PROJECT: TROPICAL DURANGO PARK - PHASE II

CITY OF LAS VEGAS INTER-OFFICE MEMORANDUM

Drainage Study for:

Tropical Durango Park – Phase II

Figure 2 – Normal depth cross section locations

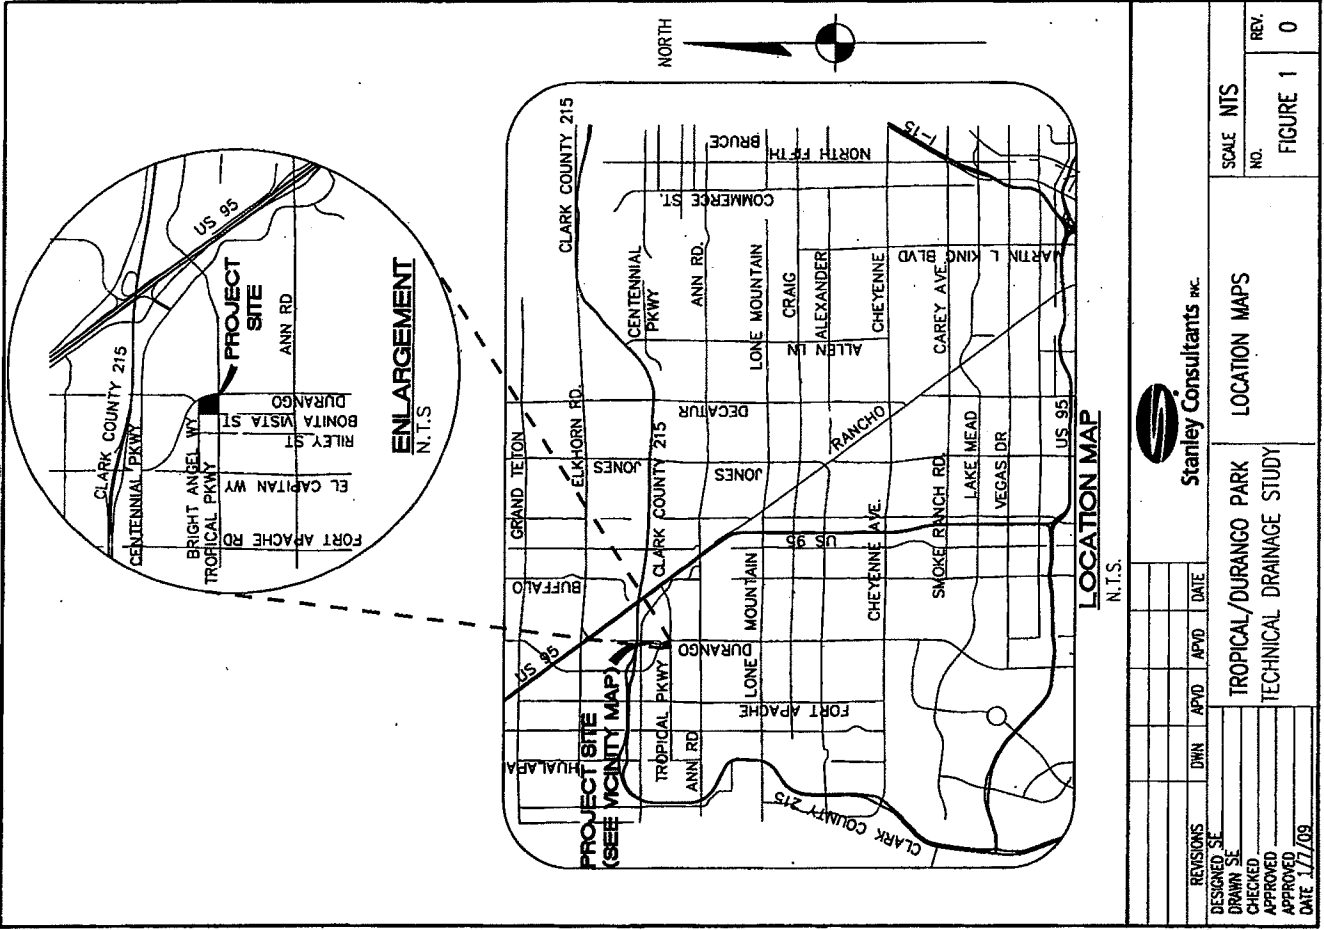
- Figure 2:** a) It appears that the "100-year" and the "10-year" Storm Event Summary annotation in the table are in the wrong order. Review and revise accordingly; b) The 100-year normal depth in Section W (B) in the existing condition is shown to be 1.74' which is hugely different from the other two sections. Correct in the next submittal.

MATCHLINE SEE BOTTOM OF DRAWING C-2

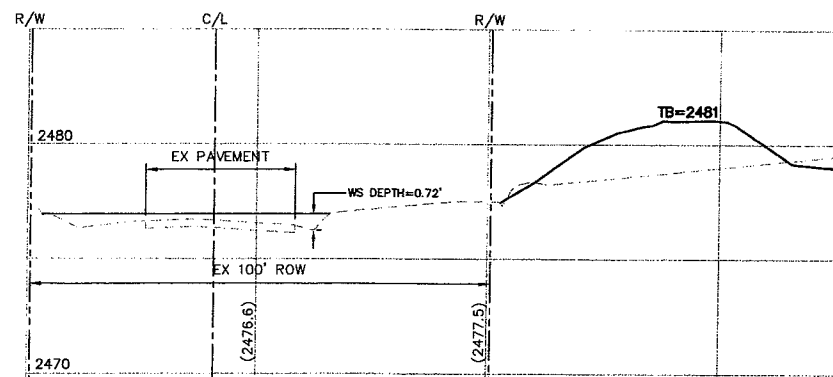
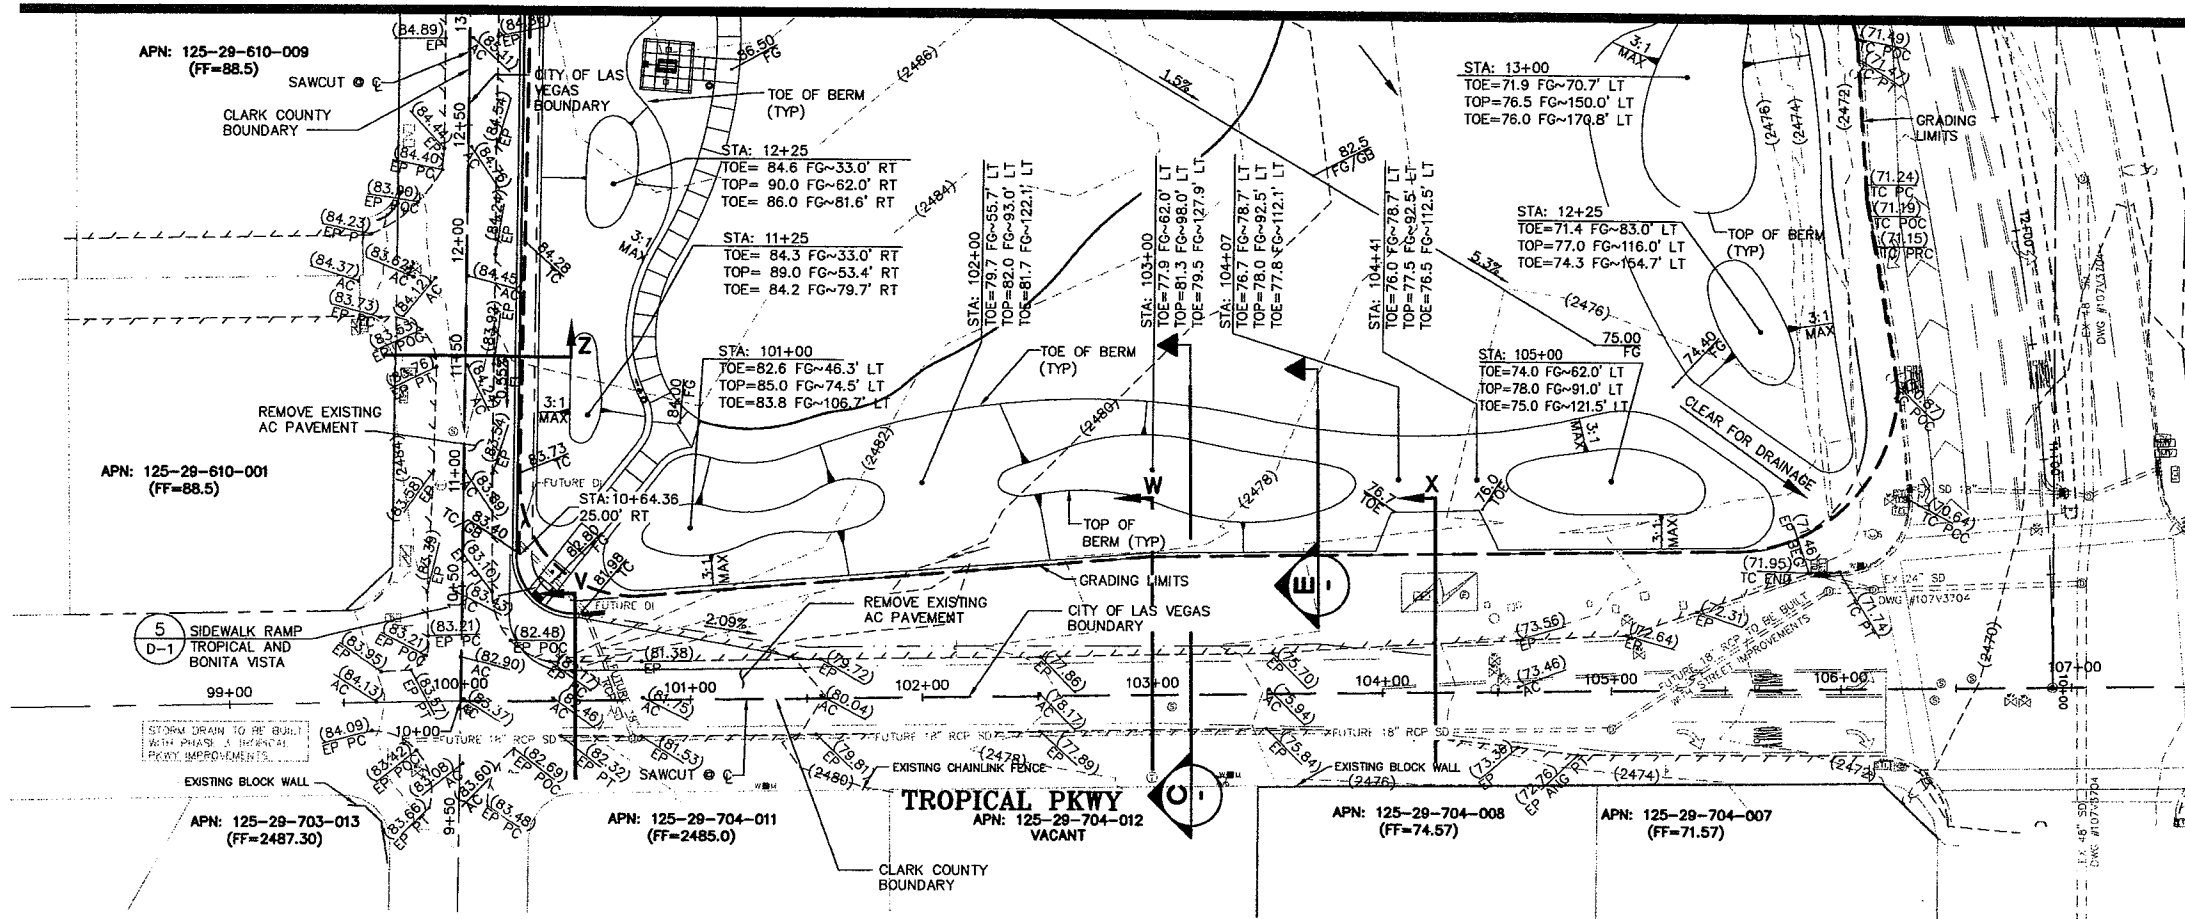
- Grading Plan (C-2):** a) Extend the proposed 18" storm drain in *Tropical Parkway* to the centerline of *Bonita Vista Street*. Revise the grading plan and all pertinent plan & profiles accordingly; b) Identify the type and size of the proposed drop inlet on the grading plan; c) Consult with *Land Development Section* regarding the extent of the overpaving requirement in *Tropical Parkway*; d) Address what the straight line running from "87.0FG/HP" to "74.40FG" is? According to the contour lines, this line appears to be a flow line in the upper half but turns to a ridge line in the lower half. A culvert is required if this line indeed discharges at the sidewalk confluence. Address and resolve in the next submittal.

Please provide offsite plan submittal for review to Clark County for work and patch in County ROW (Bonita Vista Street, Sheet C-2).
